## Proposal for amendments to UN Regulation No. 58 (Rear underrun protection)

The text reproduced below has been prepared by the expert from Germany to introduce amendments in document ECE/TRANS/WP.29/GRSG/2014/18. The entire text of document ECE/TRANS/WP.29/GRSG/2014/18 is reproduced for ease in readability. The modifications to the text in that document are marked in bold and red for new or strikethrough for deleted characters. The proposal for amendments from OICA has been added in blue.

“ **Figure 1**

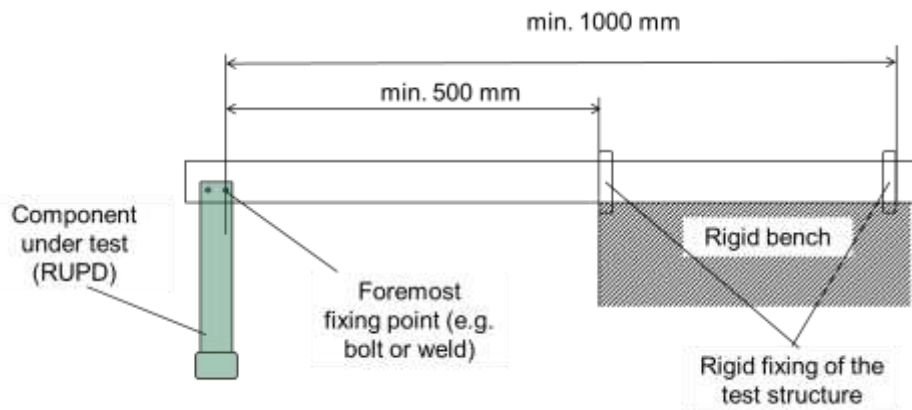
*Annex 5, Paragraph 1.2., amend to read:*

"1.2. In the case of paragraphs 1.1.2., ~~and 1.1.3~~ the parts ..... of the vehicle chassis ~~or to the rigid test bench~~ shall be ..... on the vehicle. **The part of the chassis can be fixed on a rigid test bench as shown in Figure 1, representing the minimum requirements to be fulfilled. The structures used as side rails shall be representative of the chassis of vehicles for which the underrun protection system is intended.**”

*Annex 5, insert a new figure after paragraph 1.2.:*
